REMARKS

Following review of Applicant's Amended Appeal Brief by an Appeal Conference panel, the file was returned to the Examiner with instructions. The Examiner thereafter entered a new non-final office action on March 22, 2005 that reopened prosecution and advanced new arguments for rejection of claims 1-22 ("Reopened Office Action"). This Reply to Office Action is in response to the Reopened Office Action.

FIGURES 4-5 OF MURRAY PATENT

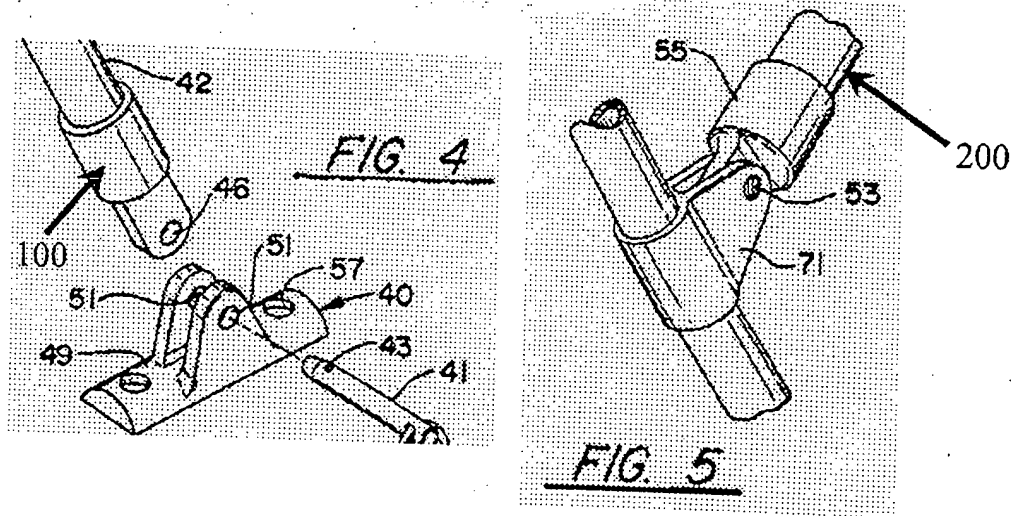
The apparatus of the Murray Patent is not universally adjustable. As is evident from the marked-up figures shown by the Examiner on page 4 of the Reopened Office Action, and reproduced on page 14 of this Reply, the component that the Examiner labeled “tub 100” allows leg 42 to be positionable in one plane only. Together, components 42 and 100 may rotate only in

one plane around the axis formed when quick release pin 41 is inserted through apertures 52 (see reproduced Figures 4-5 of the Murray Patent, and column 3, lines 58-64).

B. Structural Disagreements Marked-up Figures 4 and 5 from the Murray Patent are reproduced from the Examiner's office action in this document for an additional reason.

Beginning on page 8 of the Reopened Office Action the Examiner includes a number of comments about the arguments advanced by Applicant in Appellant's Amended Appeal Brief. For example, the Examiner states that Applicant "does not fully appreciate that figures 4 and 5 show separate sections of the assembly of figure 1." The term "figure 1" apparently refers to Figure 1 of the Murray Patent. The Examiner goes on to state: "Figures 1, 4 and 5, as depicted together above, show that element 100, while similar in structure to element 55, is in addition to and assembled away from element 55." (Emphasis added.) Applicant respectfully disagrees.

On further reflection, the Examiner will appreciate that element 100 and element 55 are identical, not similar, in structure; that the differences in structure occur in connection with the

configuration of the substrate on which component 100 and component 55 are mounted. Thus, component 100 is mounted on base 49 having a flat planar surface (see Reopened Office Action, page 4), whereas component 55 is mounted on a tube formed with T-fitting slides 71. Again, the structural difference resides in the different substrates, not in component 100 and component 55. What is more germane, however, is the fact that under no interpretation of the components of the Murray apparatus can either Figure 4 or Figure 5 be construed to show the tub and plug of Applicant's apparatus, an argument made clear in subparagraph C. below.

In addition, it is evident that the Examiner's efforts to identify in the Murray apparatus the elements of Applicant's coupler are incorrect in fact, and incorrect mechanically. Thus, on page 4 of the Reopened Office Action, immediately beneath marked-up Figures 4 and 5, the Examiner asserts that the Murray Patent shows "a tub...adjustably connectable to the base...[and] a plug...repositionably attachable to the tub...[and] a neck rotatably insertable in the plug..." That assertion fails when that same assertion includes the reference numerals assigned by the Examiner to the components of the Murray apparatus. For example, the Examiner attempts to reconstruct Applicant's coupler by stating that component 100 is a "tub," and that component 42 is a "plug" repositionably attachable to the tub. Component 42 is, however, not reasonably comparable to the variably positionable plug 72 of Applicant's coupler. Indeed, component 42 is described in the Murray Patent as one of the "legs" of the U-shaped structure that supports the canopy: see Murray Patent, column 3, lines 8-11, lines 33-38, lines 55-60, and column 4, lines 1-7. If comparable to any elements of Applicant's coupler, leg 42 would be shaft 110, shown in Applicant's Figure 5 – which is connectable to neck 74, not tub 70.

1. The marked-up figures included by the Examiner on page 4 confirm that the underside of base 40 is flat. The Examiner concedes that the underside of base 40 is a “flat planar surface.” See Reopened Office Action, page 4. A flat planar surface is not designed for mounting on a curved surface absent additional means for mounting. Nothing in the Murray Patent suggests or teaches that the Murray apparatus is intended to be mountable on a curved surface, and the Examiner points to none. Were the Murray apparatus mounted on a curved surface, it would not be mounted securely, and likely would tear loose from the hull of a craft because none of the other components attached to the Murray apparatus are variably positionable.

FIG. 5

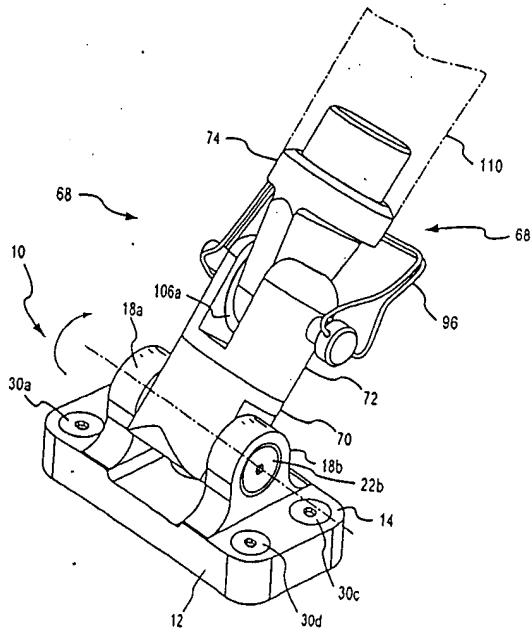
Figure 5 is a perspective view of the coupler showing possible variable positions;

Thus, as shown in Figures 5 through 8B, the semi-circular arrows demonstrate that the components of Applicant's coupler are positionable not merely in one plane like the Murray apparatus, but in a wide variety of positions, in a wide range of varying planes, along an array of combinations and permutations of x-, y-, and z-axes.

An element of Applicant's independent claim 1 is a plug repositionably attachable to the tub. See Listing of Claims, page 4, line 10. The plug is shown in Figure 5 of the Application as plug 72 as reproduced in this document.

FIG. 6

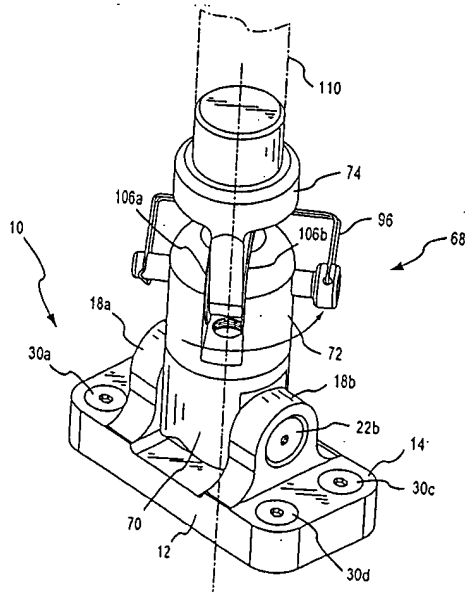
Figure 6 is a perspective view showing yet another of the variable positions of the coupler;

For Example, Figure 6, however, begins to demonstrate the mechanical departure of the coupler from the Murray apparatus. The semi-circular arrow shown on plug 72 of coupler 10 shows yet another of the variable positions of the coupler by showing that because of the unique use of plug 72 in combination and mechanical cooperation with neck 74 and tub 70, components of coupler 10 may also and simultaneously rotate around a y-axis. Figure 7 shows that a segmented portion of coupler 10, namely neck 74, may rotate around yet another z-axis. As indicated in the "Brief Description of the Drawing," Figure 8A shows that tub 70 may rotate around the axis formed by first threaded bolts 22a,b in opposing yokes 18a,b, while at the same time plug 72 may rotate in relationship to tub 70, while at the same time neck 74 may be variably positioned in yet another plane or direction -- all of which is shown again for emphasis from an alternative perspective in Figure 8B, which also demonstrates graphically that the flat bottomed base 12 is securely fastenable to a curved surface through the use of the ball washer assemblies 40.

FIG. 7

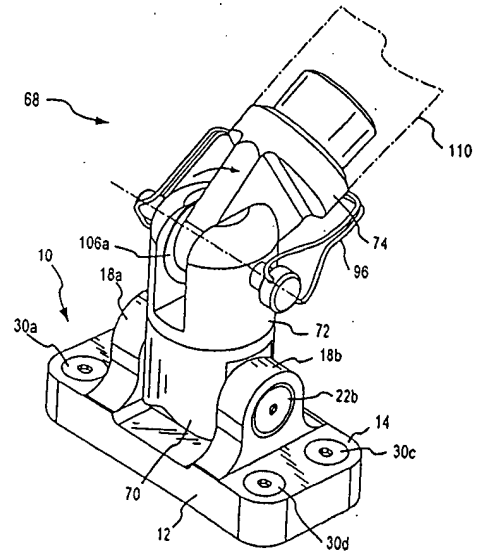
Figure 7 is a perspective view showing another variable position of the coupler;

FIG. 8A

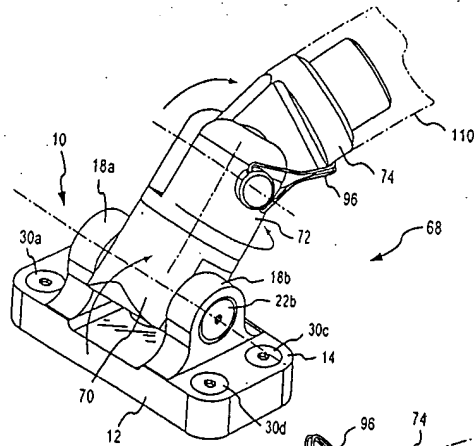
Figure 8A is a perspective view showing another variable position of the coupler;

FIG. 8B

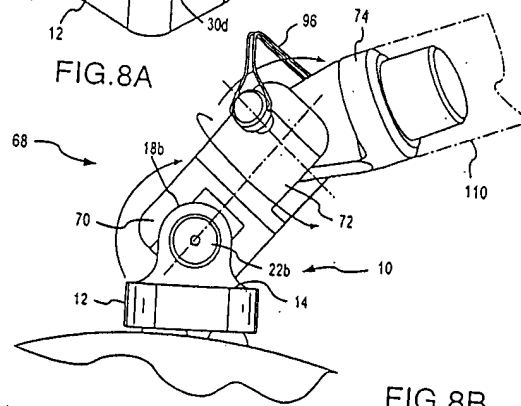
Figure 8B shows another variable position of the coupler on the ball washers...
